34-11 BEACH CHANNEL DRIVE SITE
34-11 BEACH CHANNEL DRIVE, FAR ROCKAWAY, NEW YORK 11691

**AMENDED CORRECTIVE MEASURES WORK
PLAN**

NYSDEC BCP Number: C-241141

Ref.: NYSDEC BCP# C241141
34-11 Beach Channel Drive
Queens, NY 11418
Amended Corrective Measures Work Plan & Response to CMR Comments

1. Downstream Cluster Well Installation Plan
2. Copy of Department Comments Letter

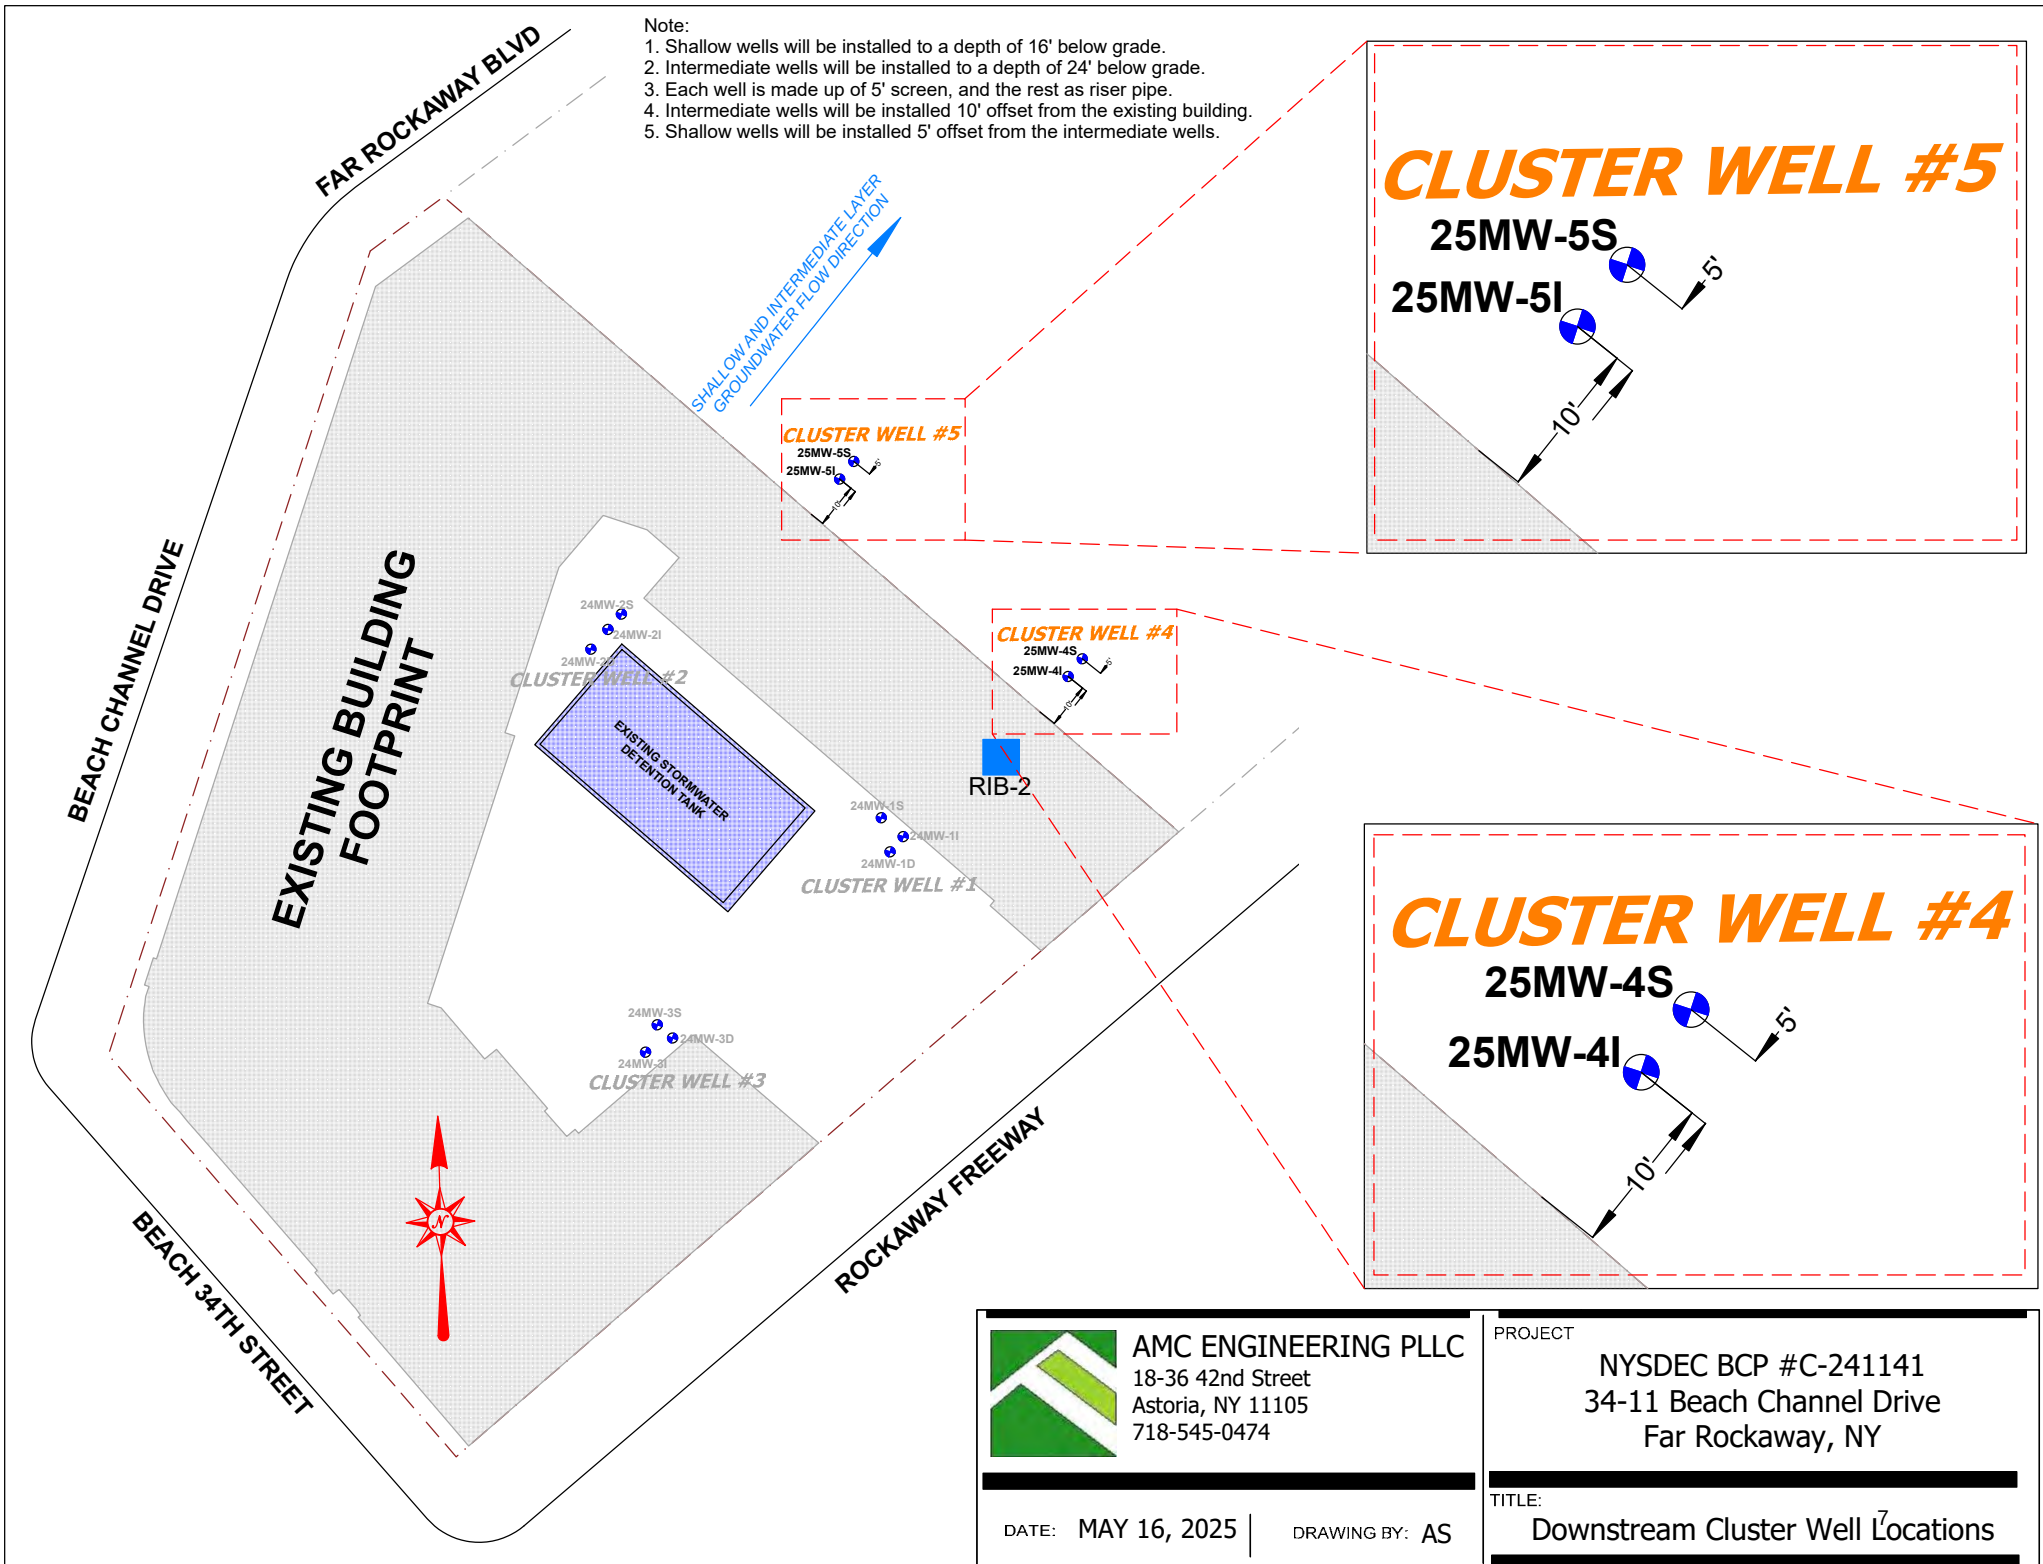
The 3 cluster wells installed at the site as part of the Corrective Measures have clarified the groundwater flow direction, which had been in question previously. The shallow and intermediate groundwater flow direction is to the north-northeast, while previously installed wells showed the groundwater direction to be generally to the west. Given this, the groundwater downgradient of the shallow and intermediate treatment zones has never been properly monitored.

NYSDEC is working on securing access to the neighboring BCP site (CPB Site, site no. C241158) so that you may install shallow and intermediate wells downgradient of the treatment zone. Within 30 days of the date of this letter, please submit an amendment to the Corrective Measures Work Plan to install monitoring wells downgradient of the treatment zone at the neighboring site.

1. Install two (2) new cluster wells on the adjacent property, as shown in the attached Figure. Each cluster consists of two wells (one screened for the 11-16' interval, and the second screened for the 19-24' interval), for a total of four (4) wells.
2. Install data loggers in all four newly proposed wells, in addition to four previously installed wells (total 8), to determine the effect of tidal influence and other factors that may influence the groundwater flow direction.
3. Survey top of casing of all onsite and offsite wells, relative to NAVD88 datum.
4. Collect groundwater samples from 25MW-4S, 25MW-4I, 25MW-5S, and 25MW-5I, to establish groundwater quality in the downstream location.

A total of two (2) cluster wells are proposed in the shallow and intermediate layers, on the adjacent property. Each cluster well will consist of two (2) monitoring wells, denoted as “Monitoring Well Shallow (MW-S)” and “Monitoring Well Intermediate (MS-I)”. For two clusters, this is a total of four (4) monitoring wells.
